WOODMEN HILLS METROPOLITAN DISTRICT REGIONAL WATER RECLAMATION FACILITY GRADING AND EROSION CONTROL PLAN

WHMD RWRf STORM IMPROVEMENTS
EL PASO COUNTY, COLORADO
GEC PLANS
COVER SHEET

WHMD RWRF STORM IMPROVEMENTS
EL PASO COUNTY, COLORADO
GEC PLANS
GEC INITIAL PLAN

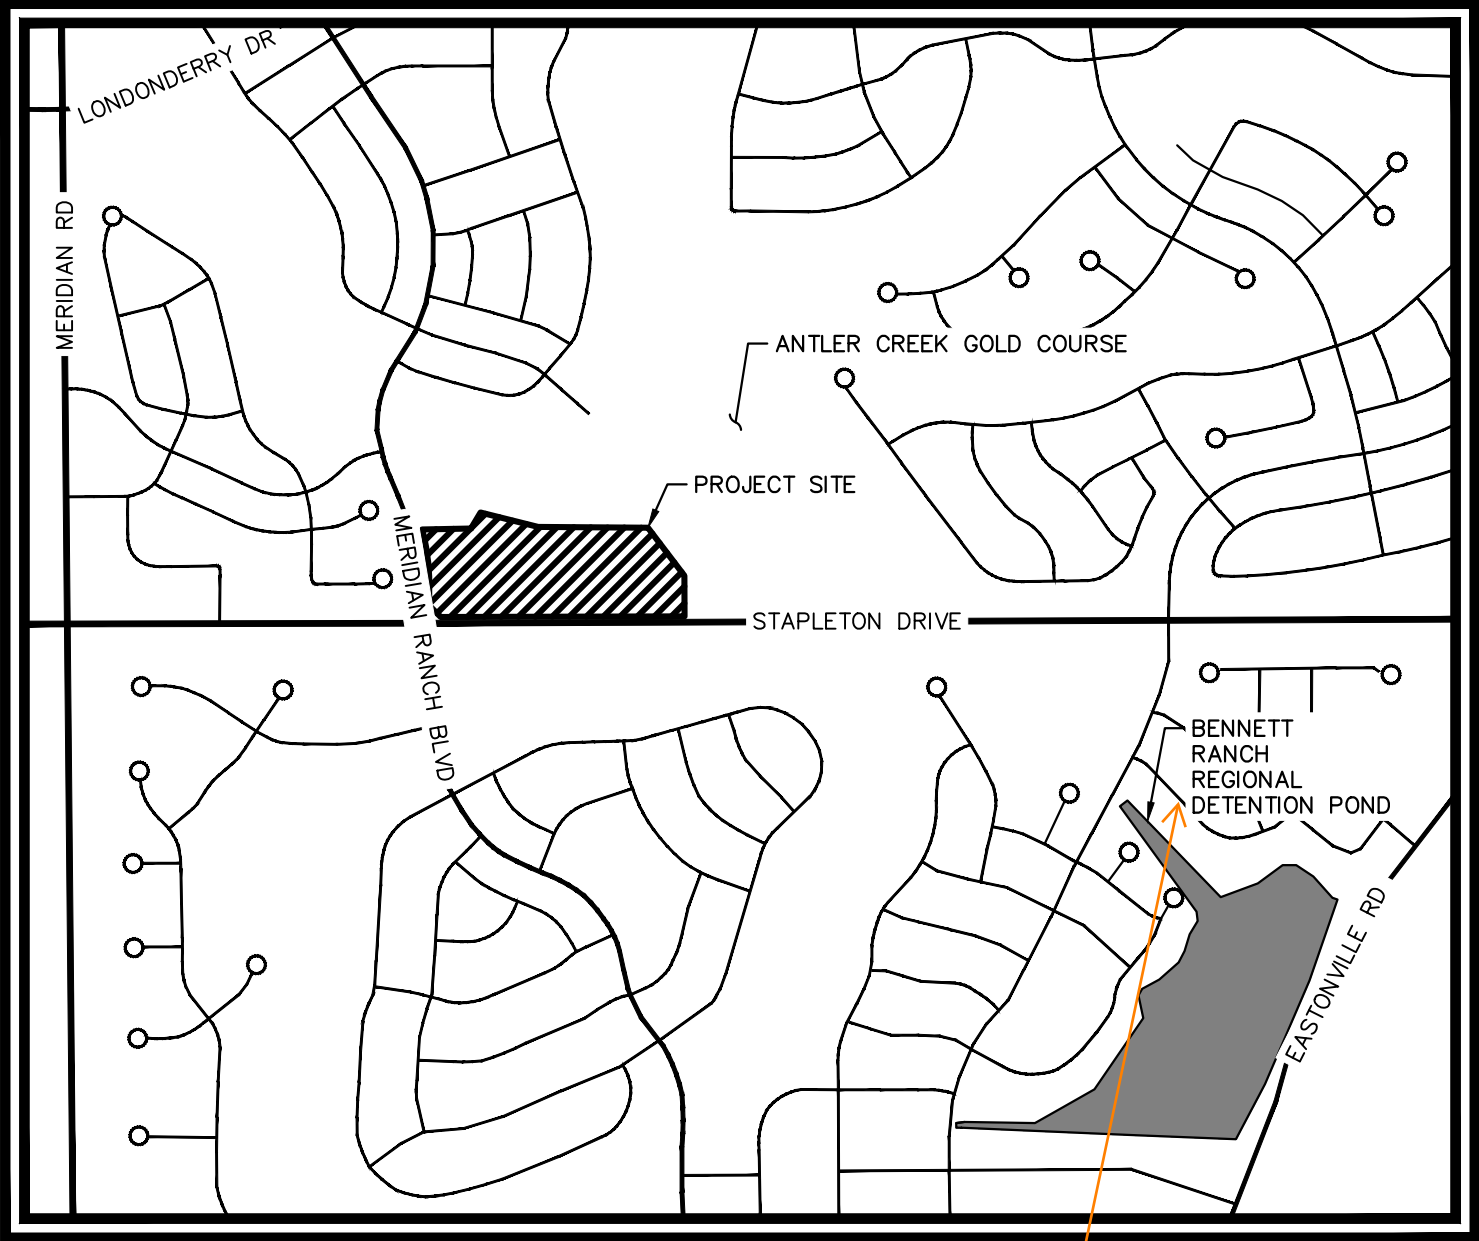
GEC Checklist Item EE.
Per his request, please
also add Josh's middle
initial "J." here

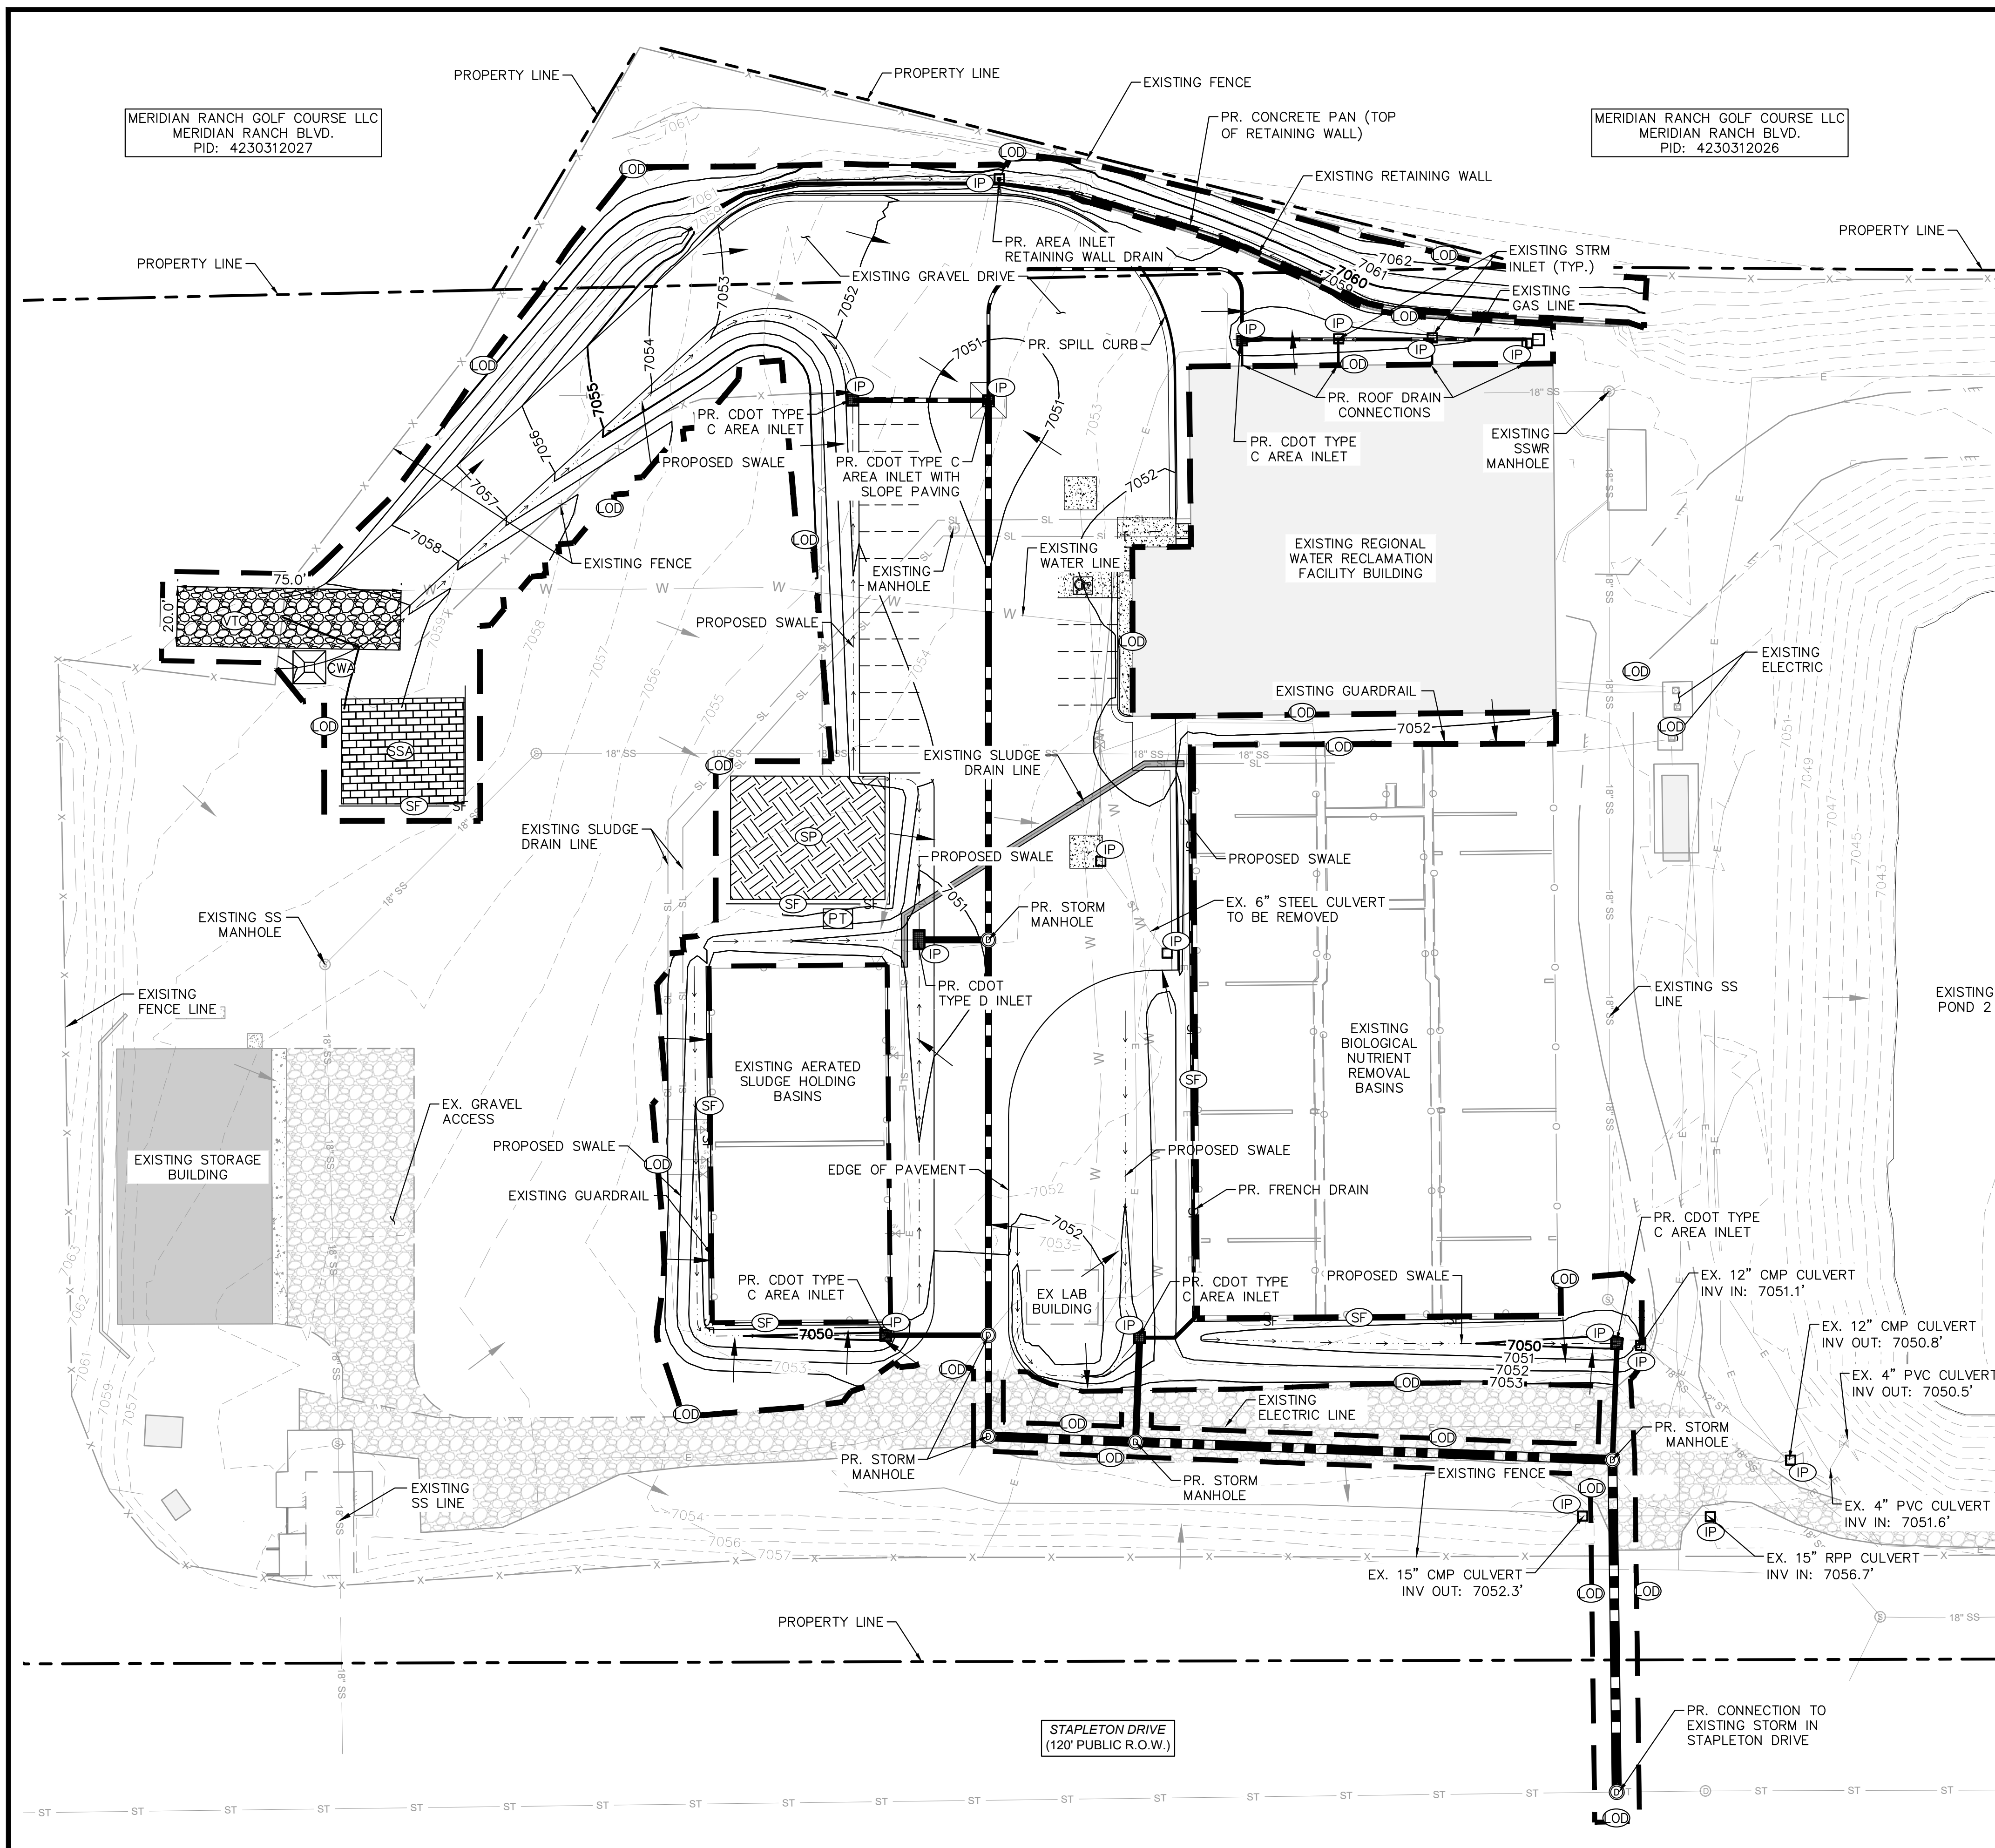
replace all mentions of Adams County with El Paso County.
